PLANNING & ZONING August 07, 2025 5:30 PM City Hall

MILLS CITY PLANNING COMMISSION

Resubdivision of Lots 14 & 15, Blk 12, Town of Mills Final Plat

Ridgewest Addition

MINOR BOUNDARY ADJUSTMENT PLAT OF

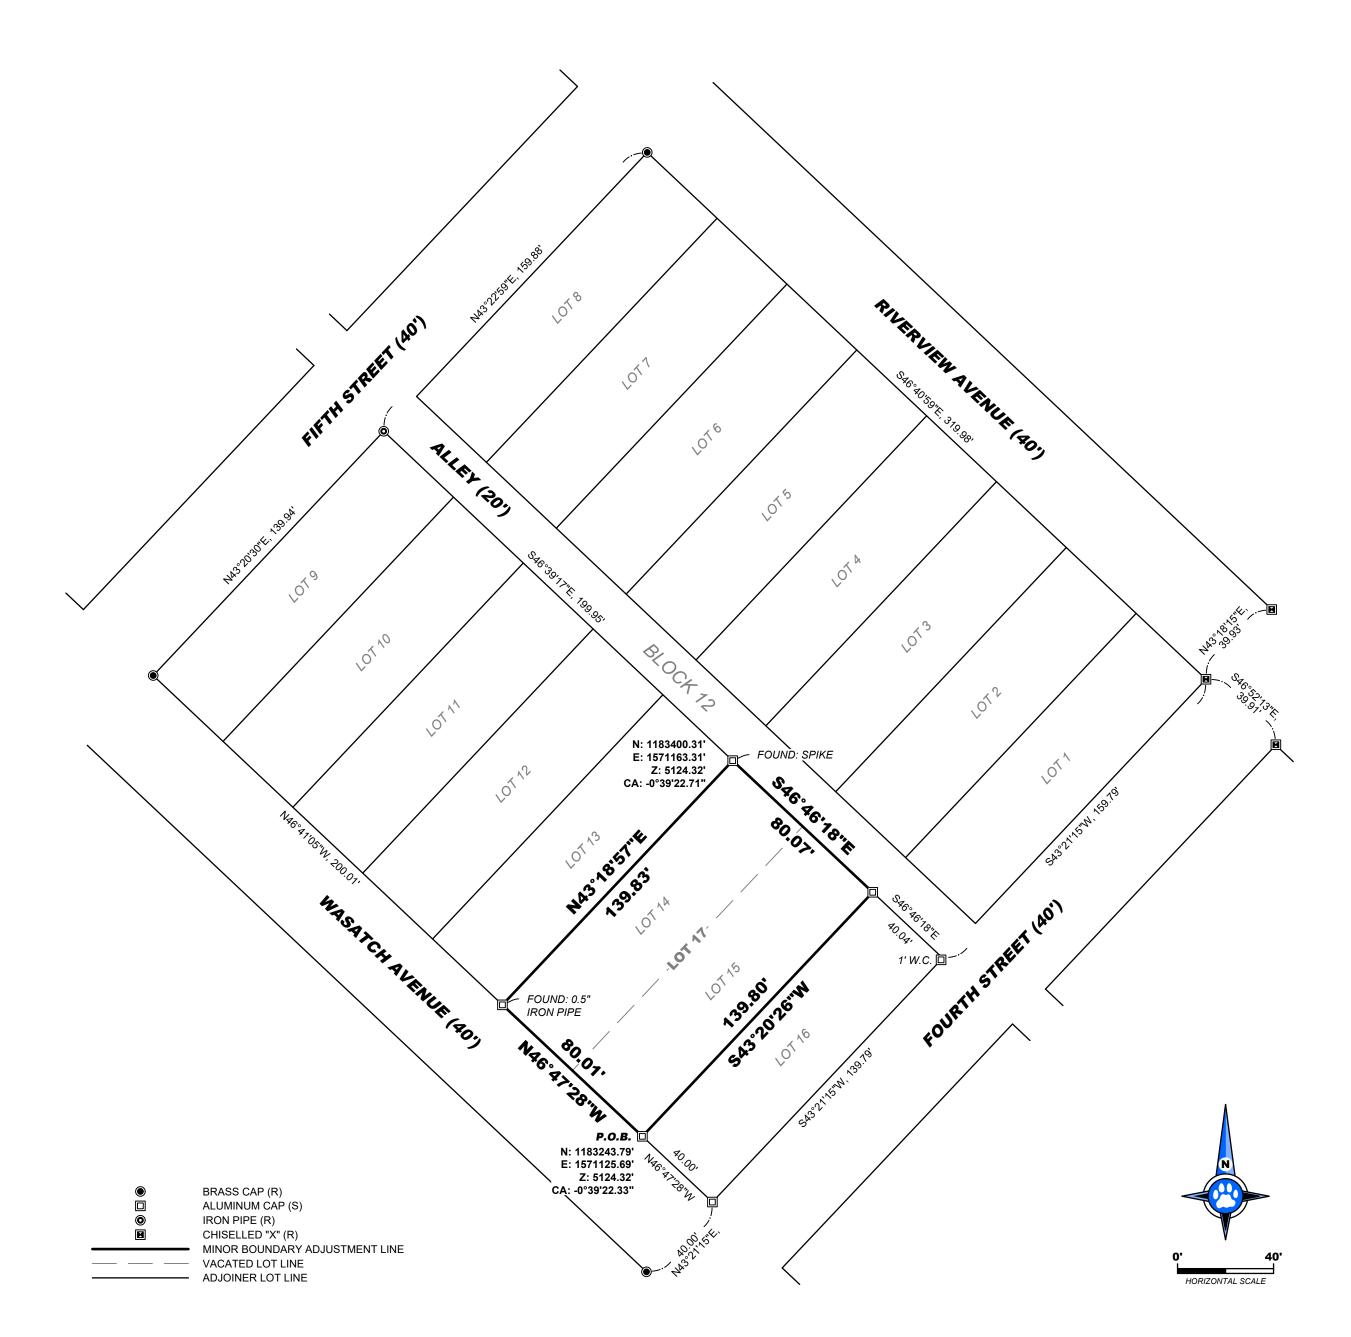
- 1. Add a 5' utility easement along the front lot line.
- 2. Add the statement to the dedication "All streets shown hereon have previously been dedicated to the use of the public."
- 3. Cosmetic changes to the plat:
 - a. Add the lot size (in acres) to the plat face.
 - b. Remove the labels for Lots 14^{-6} 5 and the previous lot line

- 4. Survey Reviews:
 - a. Add a vicinity map with the plat name label within
 - b. Provide record dimensions and distances
 - c. Add CF to each SPC given
 - d. Recommend bounding the legal description to the adjoining lots, not the ones being vacated.

Preliminary Plat

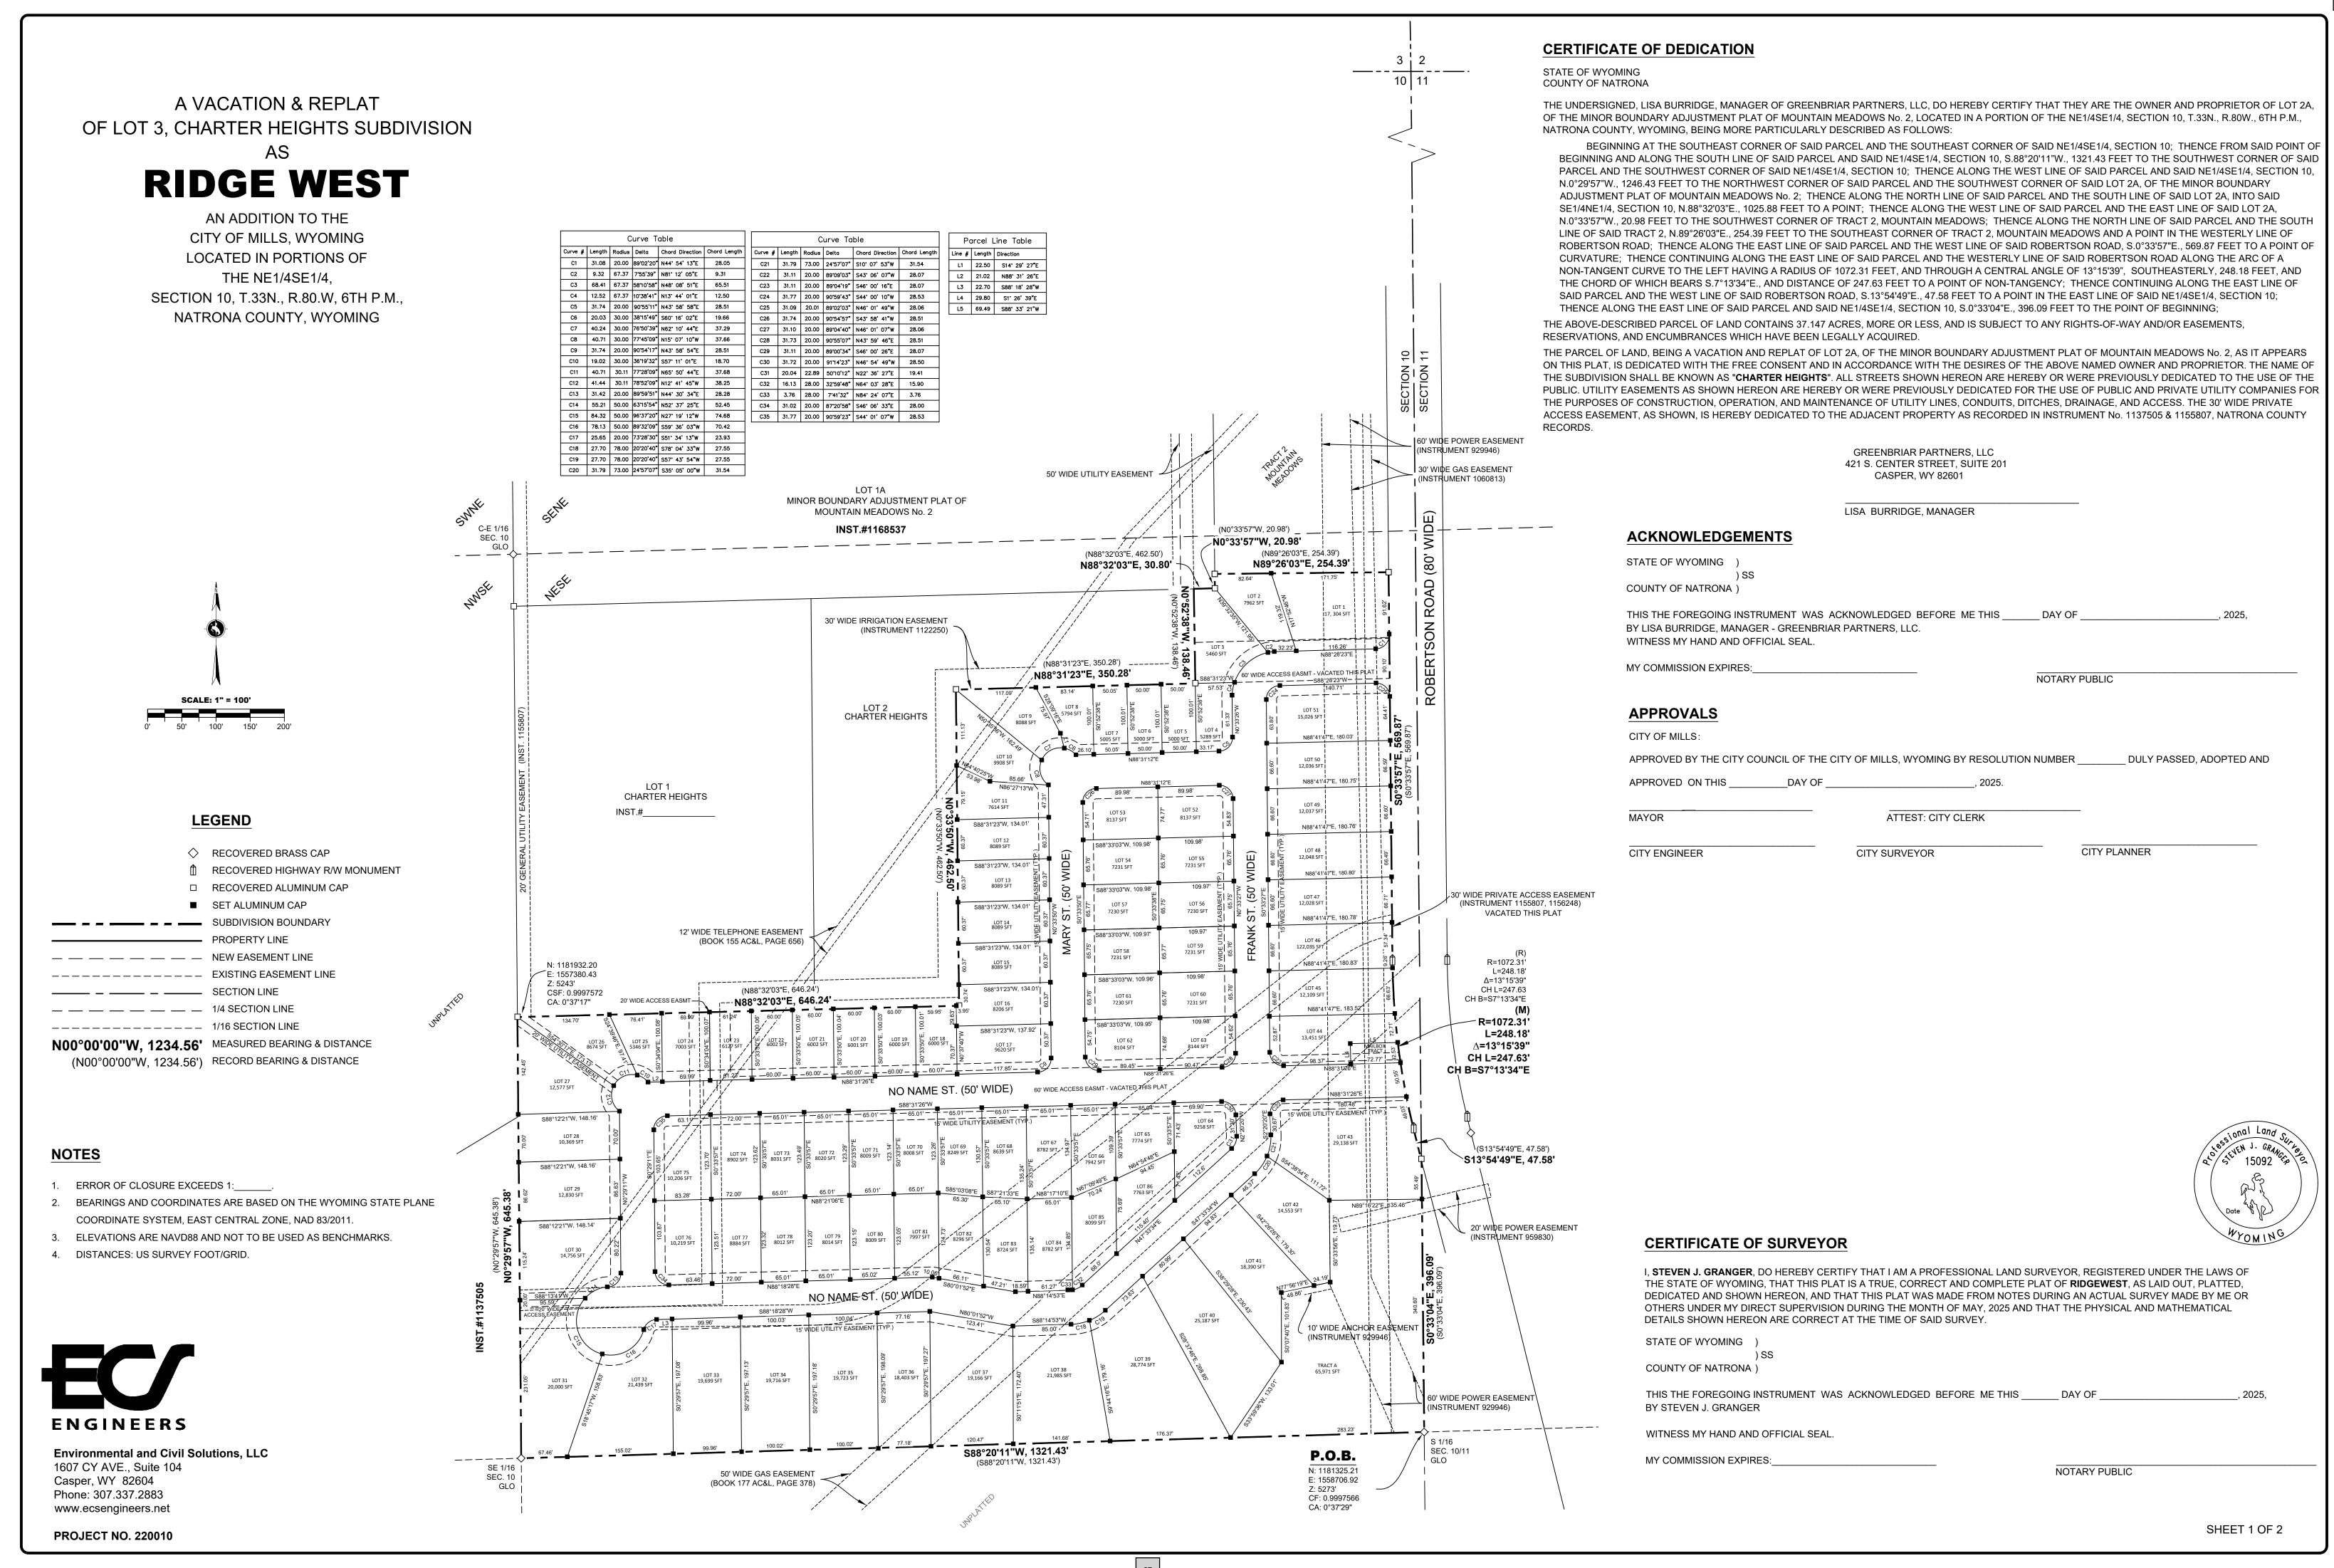
- 2. The Certificate of Dedication needs to be updated with the correct legal description and to address the name discrepancy with the Charter Heights Plat, update the Ridgewest boundary and acreage and the vacation language.

- b. Discuss providing secondary access from the subdivision to Poison Spider Lane.
- 4. Discuss road names. Provide a list of potential subdivision road names for review.

- 6. Submit a Preliminary Drainage Study
- 7. Submit preliminary plans and/or a general narrative for all proposed water, sewer and storm sewer distribution and collection facilities.

- 10. Provide site plans showing buildable area for Lots 23, 37, 44
- 11. Submit organizational documents for Greenbriar Properties, showing who is authorized to sign on behalf of the corporation.

- 12. Survey & GIS Review:
 - a. Add a Set Brass Cap symbol and show on exterior corners, where applicable.

- a. Remove all easements that are being vacated via this plat, including:
 - i. The 30' wide private access easement
 - ii. The 60' wide access easemt
- b. Do not show easements not affecting this subdivision on the plat face
- c. Provide labels for all easements on both Sheet 1 and Sheet 2.
- d. Add a vicinity map
- e. Correct the SF label on Lot 46
- f. Provide a summary on the plat face that includes:
 - i. The number of proposed lots
 - ii. Total acreage of the subdivision
 - iii. Total acreage of dedicated public right-of-way
